## ClubSwan 42 Deck Fittings

Notice #02/2019

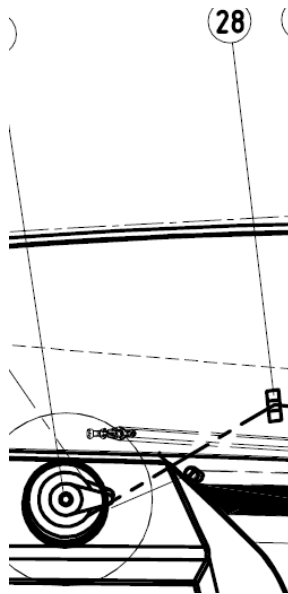
A request has been made to consider an alternative the Scammel for Jib Sheet HCP1808 (Item 28 on Deck Plan as shown below)

Following discussions with teams it is agreed that this fitting may be changed with Single Footblock to reduce the wear on the Jib Sheets.

The agreed alternative is the Harken 75mm Single Aluminium Footblock – Part No. 3234
